Comments to proposed crash pulses at 3:rd RESS meeting

Autoliv Research

§3.4.1.2.1 Proposed pulses vs. frontal impacts USNCAP (stiff barrier)

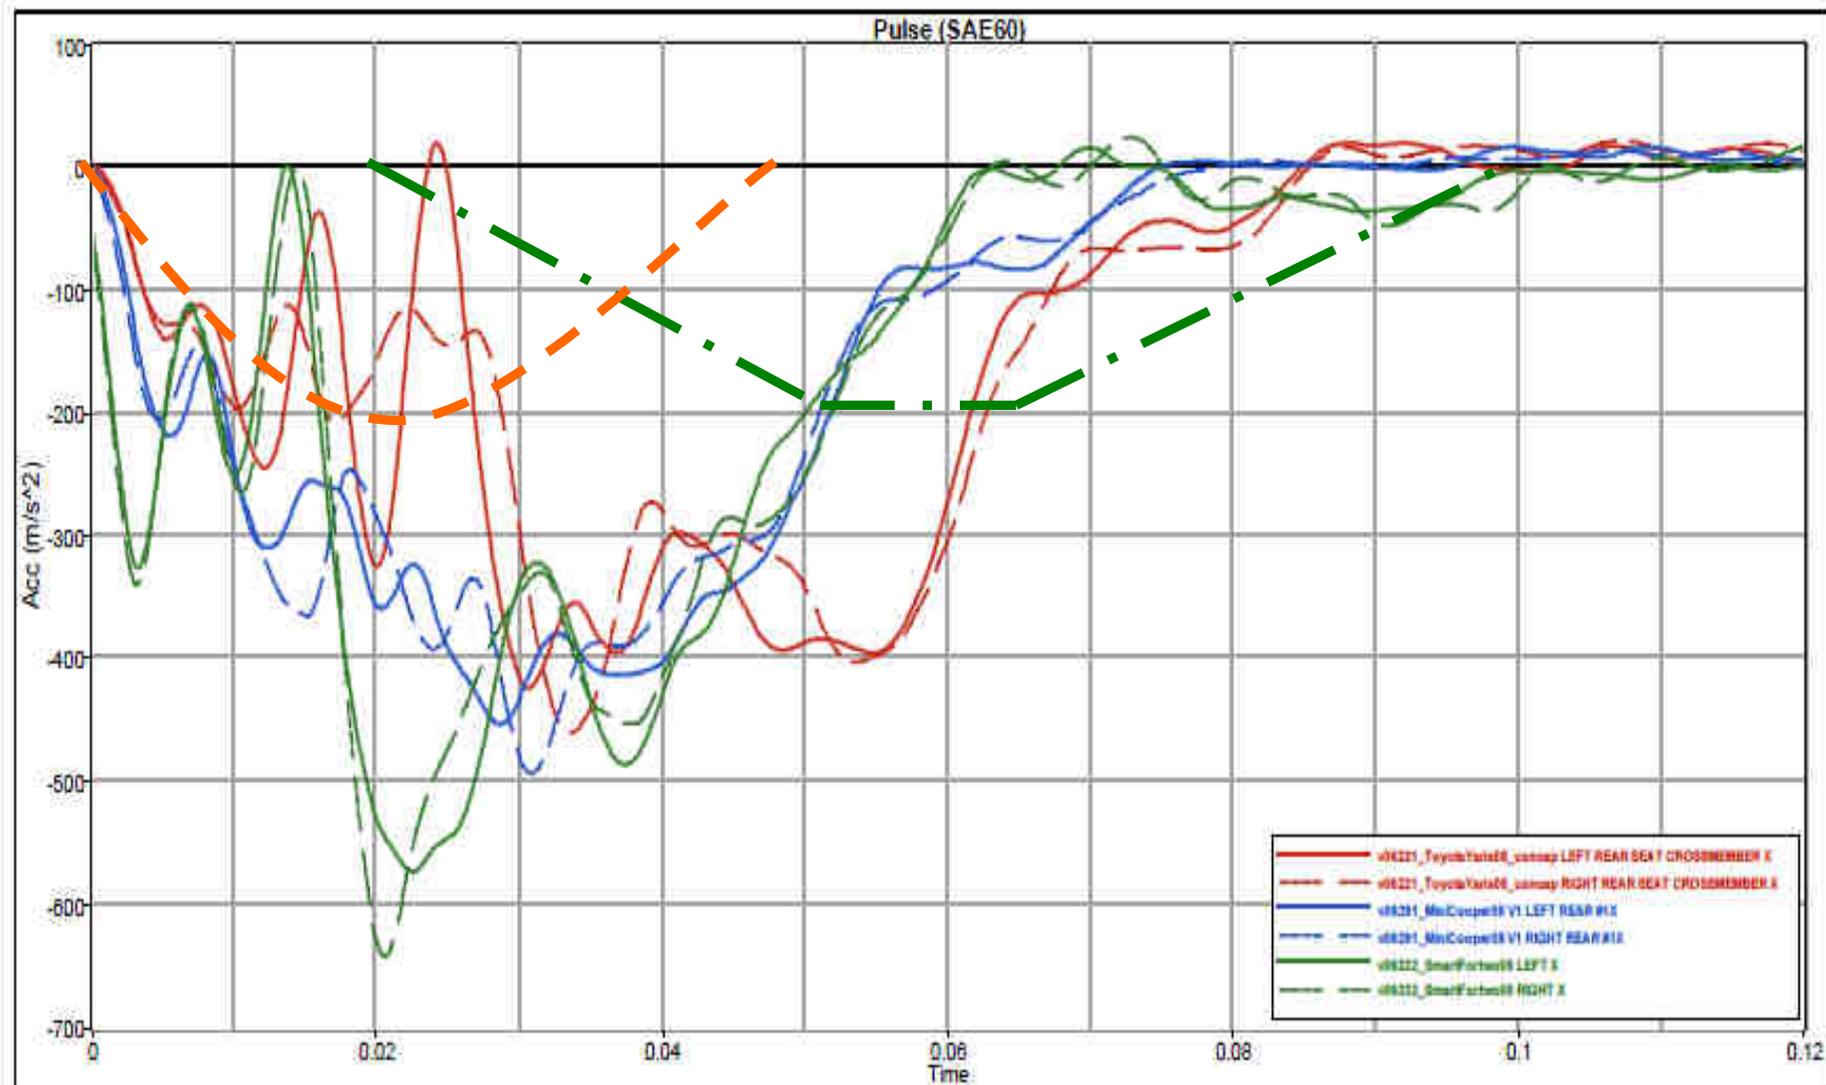
Comment: Small vehicles have been chosen for the study since the major part of the first EV's that have reached the market belongs to this category. A large part of future EV's can be expected to have properties similar to vehicles found in current small vehicle category.

§3.4.1.2.1 Proposed pulses vs. frontal impact IIHS tests

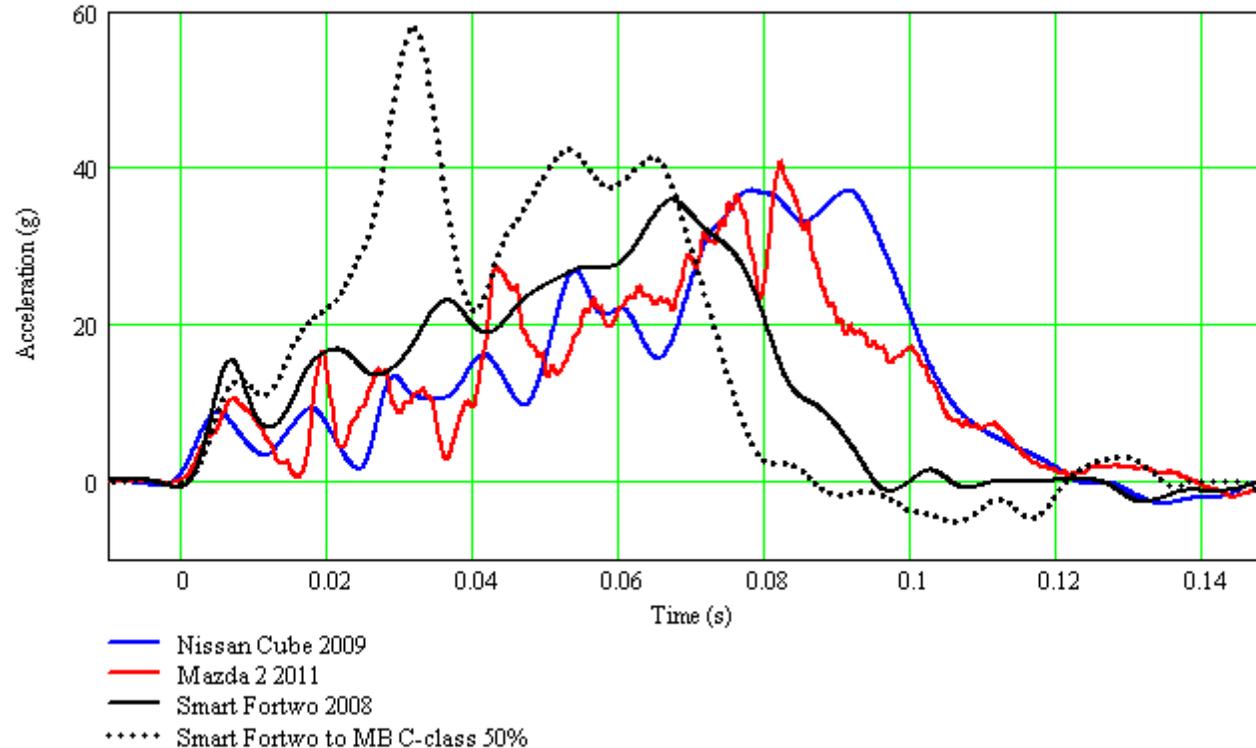
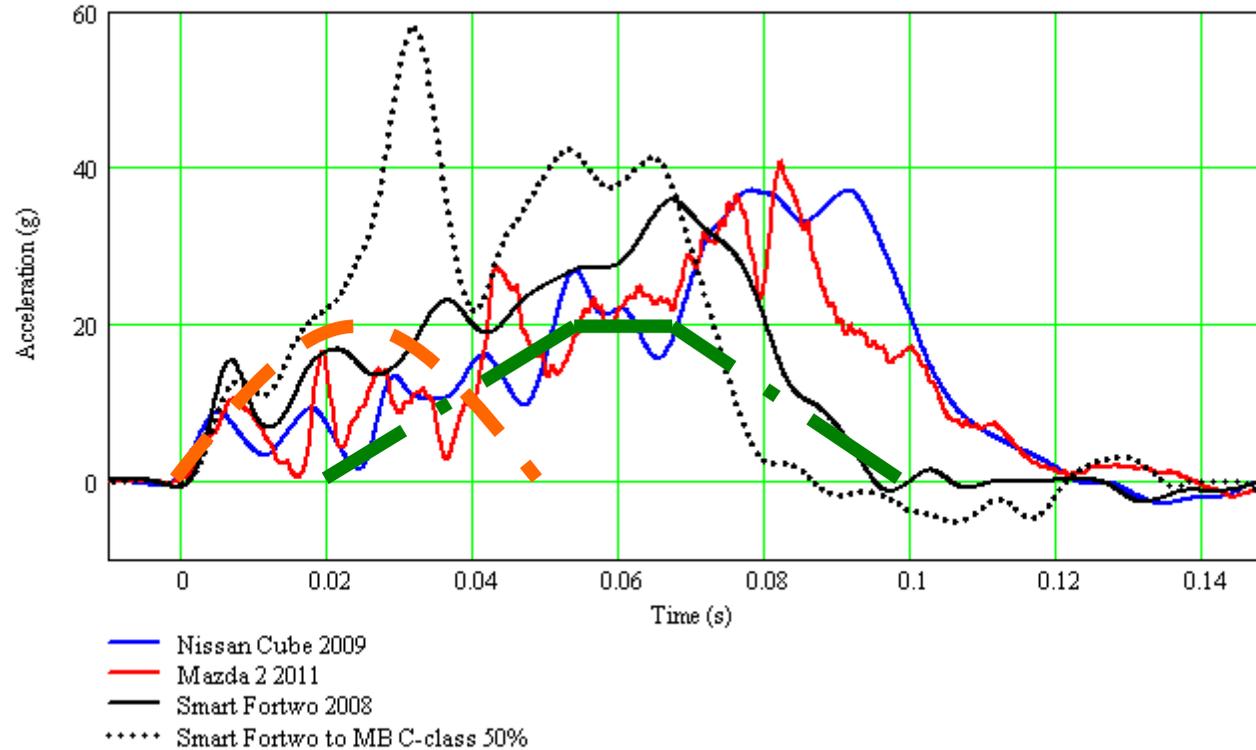
Comment: In the impact to the relatively soft offset deformable barrier (ODB), a considerable amount of the impact energy is absorbed by the ODB. The acceleration levels reaches approx. 35g (solid curves). In the vehicle to vehicle crash, the smaller vehicle experiences considerably higher acceleration levels than in the ODB test (dotted curve).

Small new (09) vs. large old (96)

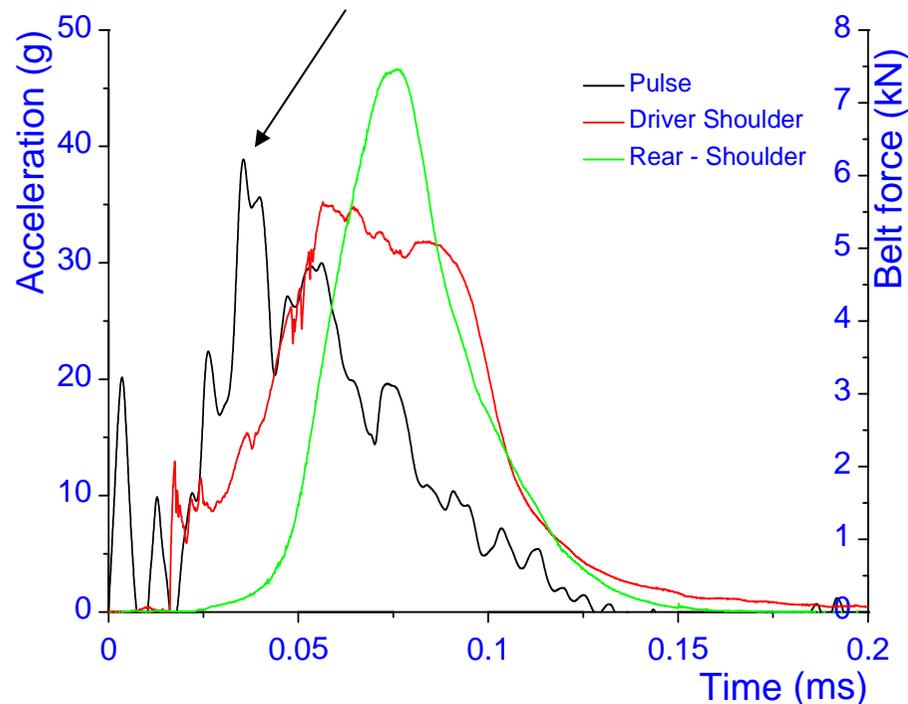
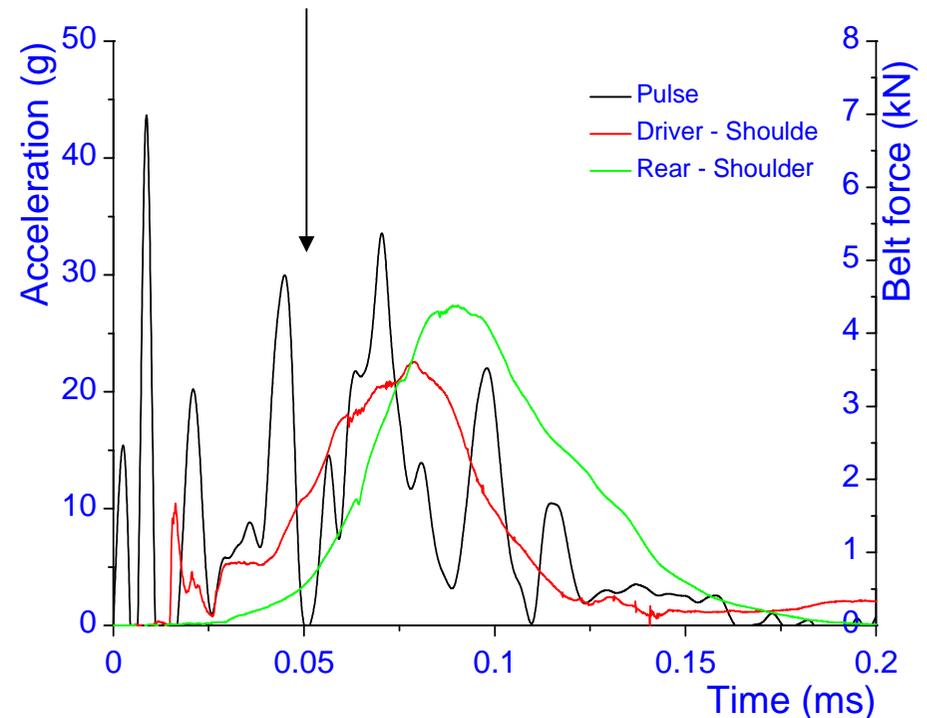
Comment: The smaller vehicle experiences high acceleration levels, even though the counterpart is soft in comparison to the small car. The small vehicle would experience even higher acceleration levels if the counterpart would be of more modern design (often higher stiffness).
